BIDDERS BULLETIN

PROJECT: New Auto Service & Car Wash Building
Modern Muffler Tire Pro
1402 South Jeffers
North Platte Nebraska

BB-1

DATE ISSUED: April 23, 2012

SLAB HEATING SYSTEM PIPING SCHEMATIC - CAR WASH

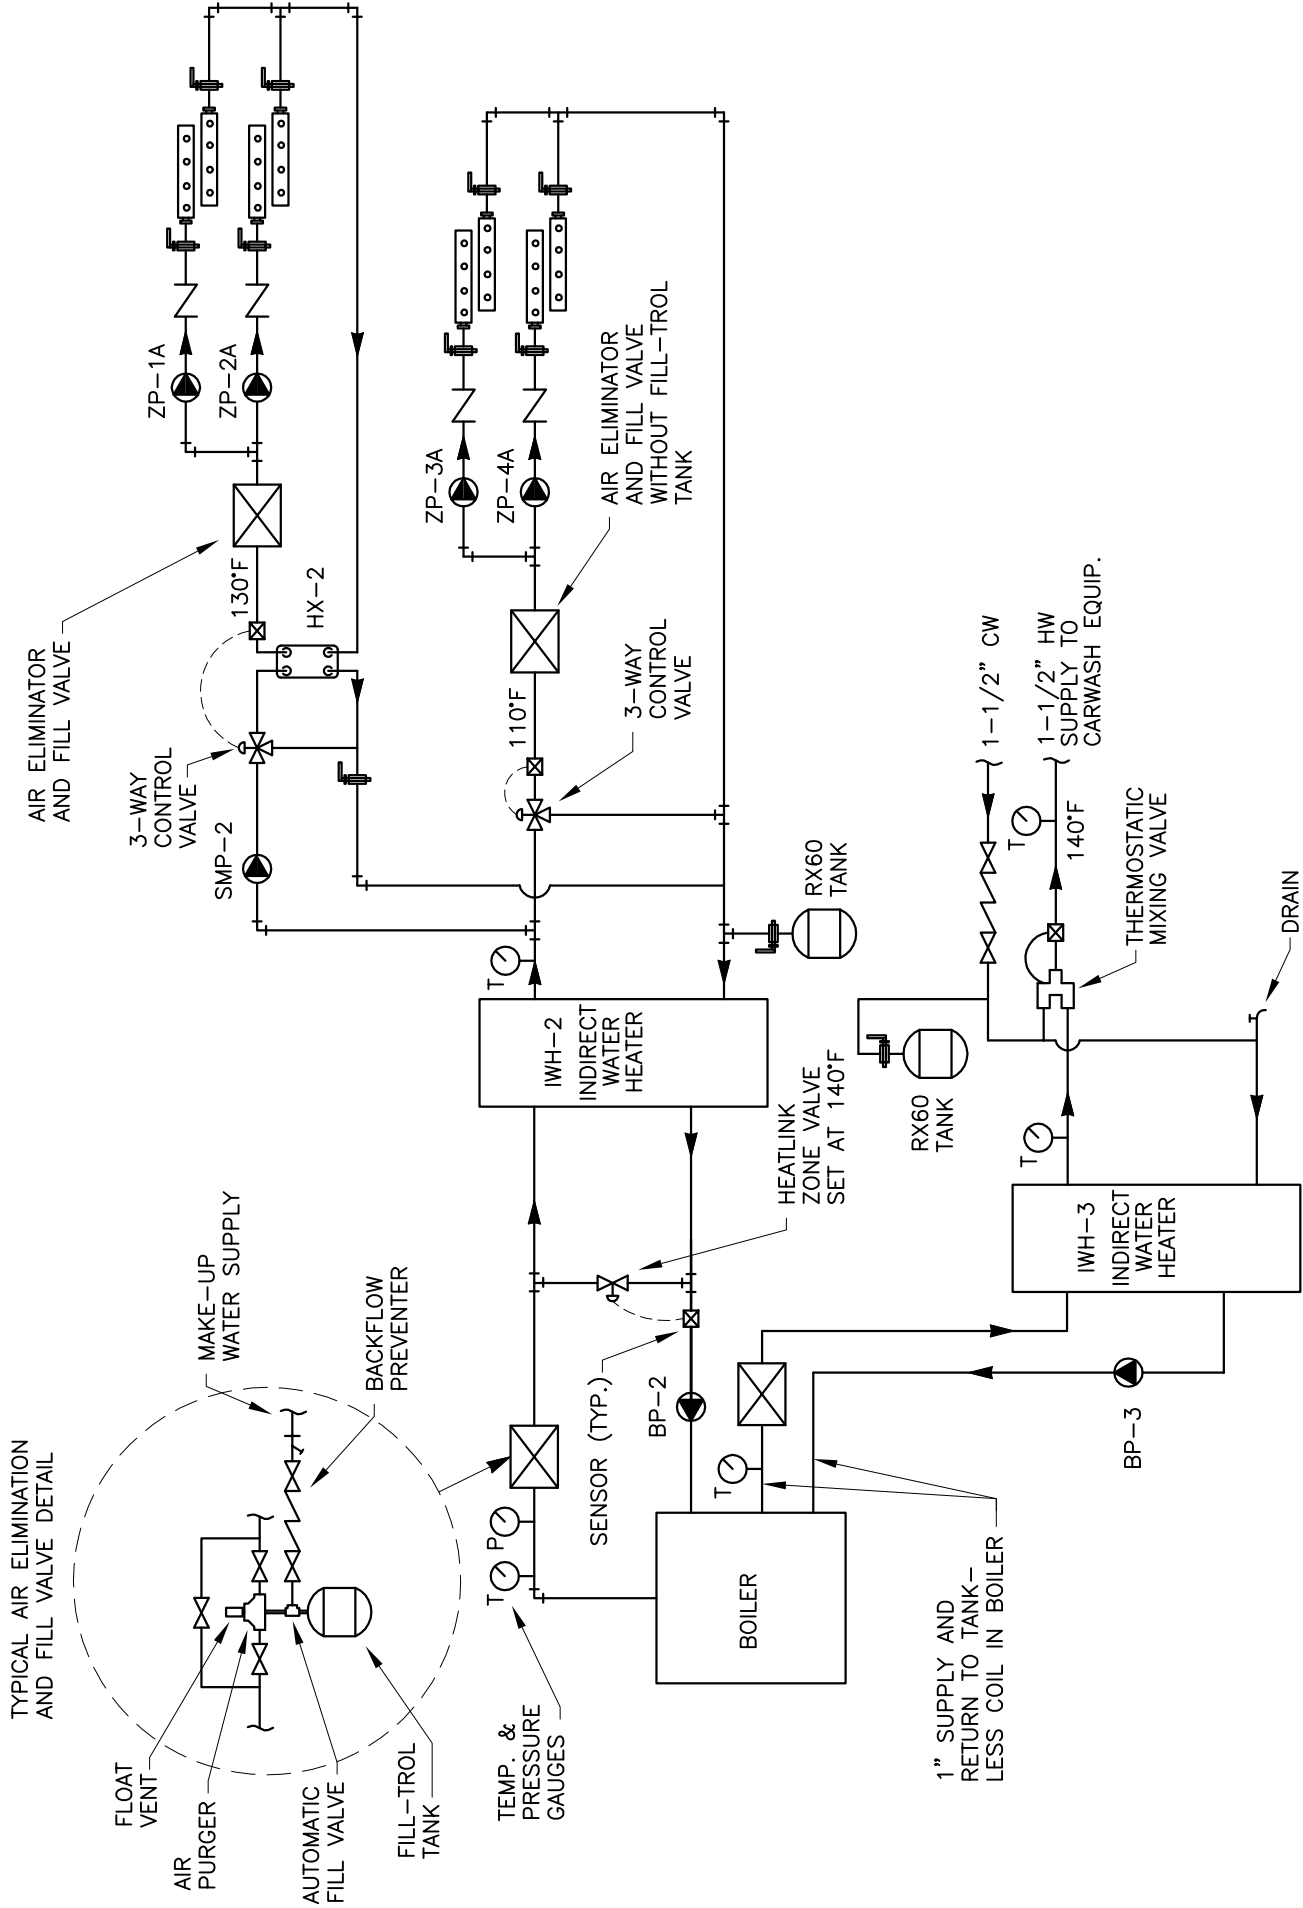
Item #4: Slab Heating System Piping Schematic – Car Wash, Sheet M200 – See attached revised drawing.

SLAB HEATING SYSTEM PIPING SCHEMATIC - SERVICE STATION

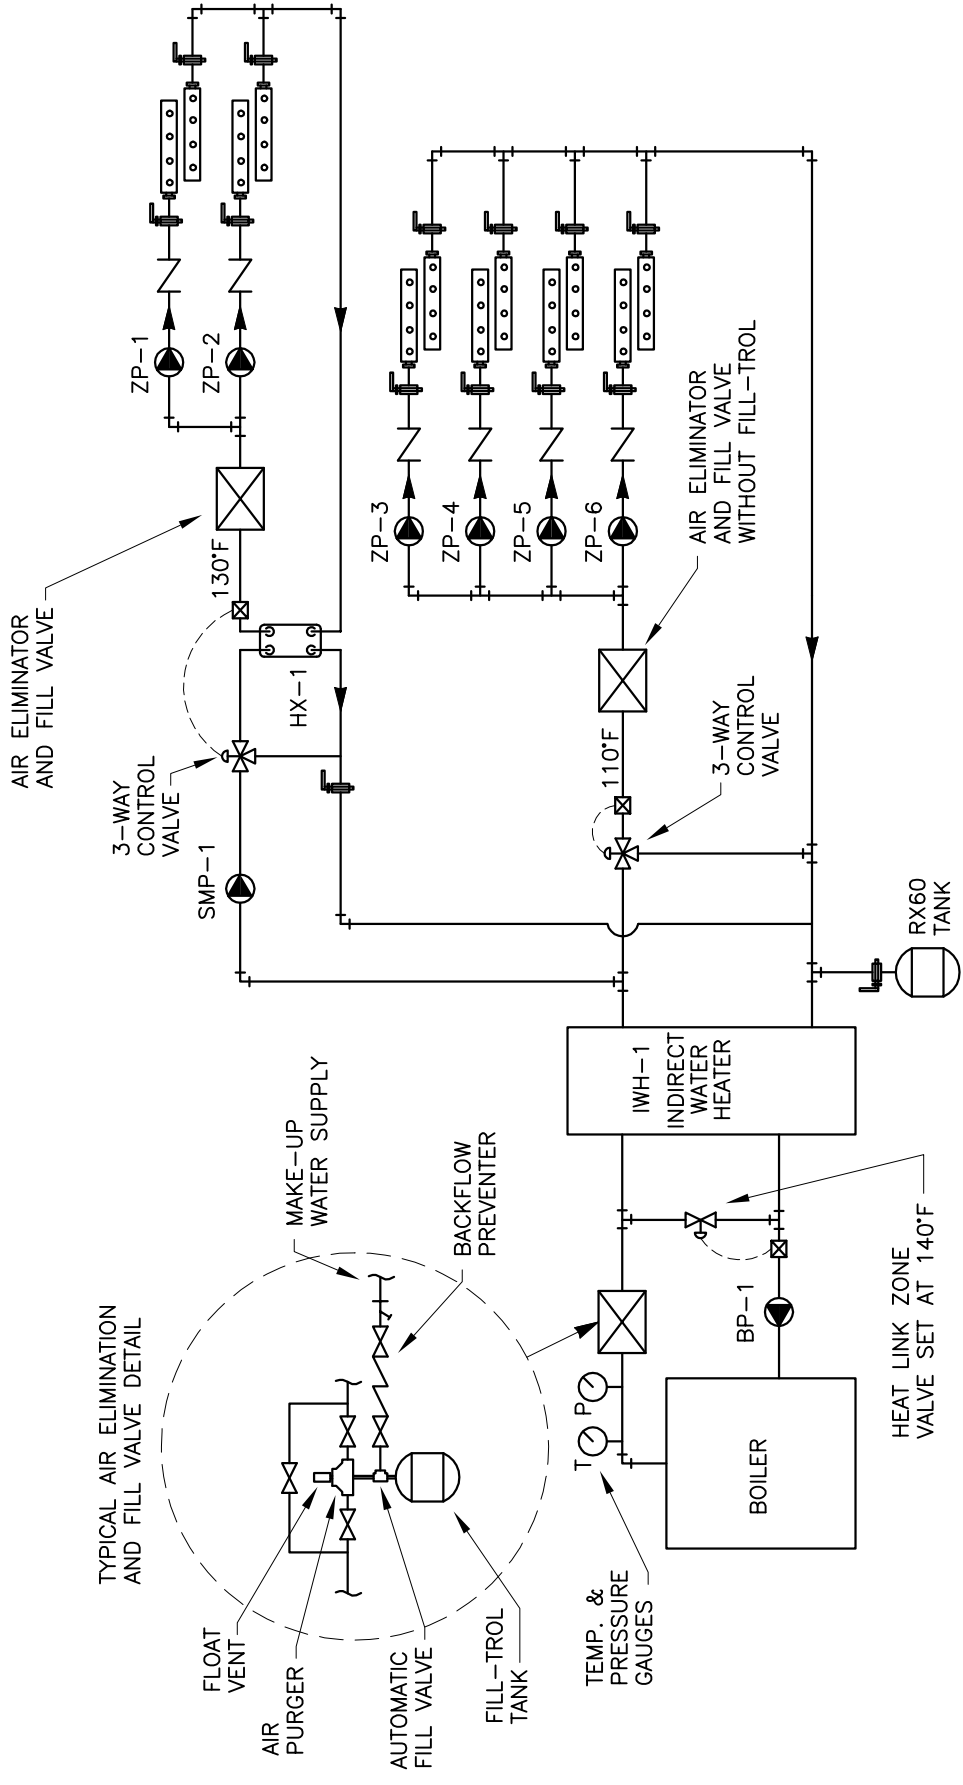
Item #3: Slab Heating System Piping Schematic – Service Station, Sheet M100 – See attached revised drawing.
